Access Compliance Report

Public Rights-of-Way

(Curb Ramps)

Intersection ID: 17926	Main Street: N_SHARON_AMITY_RD	Cross Street: RANDOLPH_RD	Location: SE
ADA ID: 9D2EE8174CF8	Ramp Type: PerpDiag	Initial Pass/Fail: Fail	Overall Compliance: No
Severity Score: 13.75			
Codes/Mitigation Info/Possible Solution		Field Measurements/Component Compliance

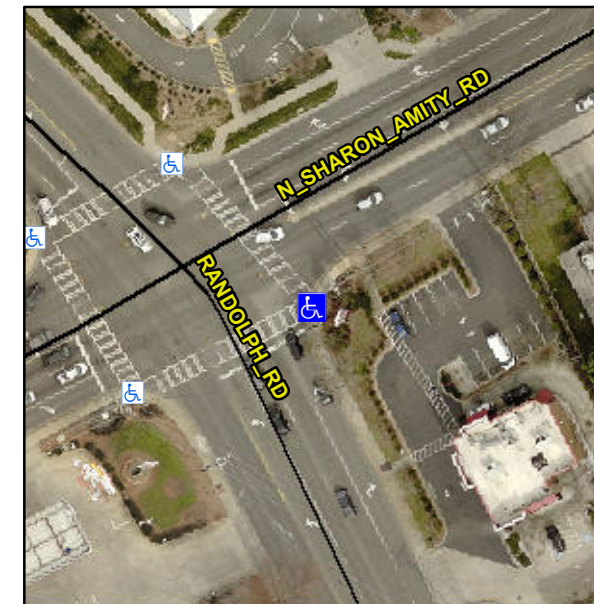
R304.2.2, R304.5.3

Compliance	Description	Data	Compliance	Description	Data
N/A	Ramp Length (in)	60.0	No	Ramp Slope (%)	8.7
Yes	Ramp Width (in)	48.0	No	Ramp XSlope (%)	3.5
N/A	Flare Type LT	N/A	N/A	Flare Type RT	N/A
N/A	Flare Slope LT (%)	N/A	N/A	Flare Slope RT (%)	N/A
N/A	Flare Traversable LT?	N/A	N/A	Flare Traversable RT?	N/A
N/A	Landing Length (in)	N/A	N/A	DWS Provided?	N/A
N/A	Landing Width (in)	N/A	N/A	DWS Contrast?	N/A
N/A	Landing Slope (%)	N/A	N/A	DWS Length (in)	N/A
N/A	Landing X Slope (%)	N/A	N/A	DWS Full Width?	N/A
N/A	Landing Curb? (Y/N)	N/A	N/A	DWS Offset (in)	N/A
N/A	Shared Landing?	N/A			
N/A	Gutter Ponding?	N/A	N/A	Gutter Slope (%)	N/A
N/A	Gutter Lip Ht (in)	1.0	N/A	Gutter X Slope (%)	N/A
N/A	Painted X Walk1?	Yes	N/A	Painted X Walk2?	Yes
	X Walk 1 Direction	To N		X Walk 2 Direction	To W
N/A	X Walk 1 Width (in)	111.0	N/A	X Walk 2 Width (in)	109.0
	X Walk 1 Slope (%)	1.2		X Walk 2 Slope (%)	1.1
	X Walk 1 X Slope (%)	1.3		X Walk 2 X Slope (%)	1.0

Remove & Replace Curb Ramp With Two New Directional Ramps or Equivalent.
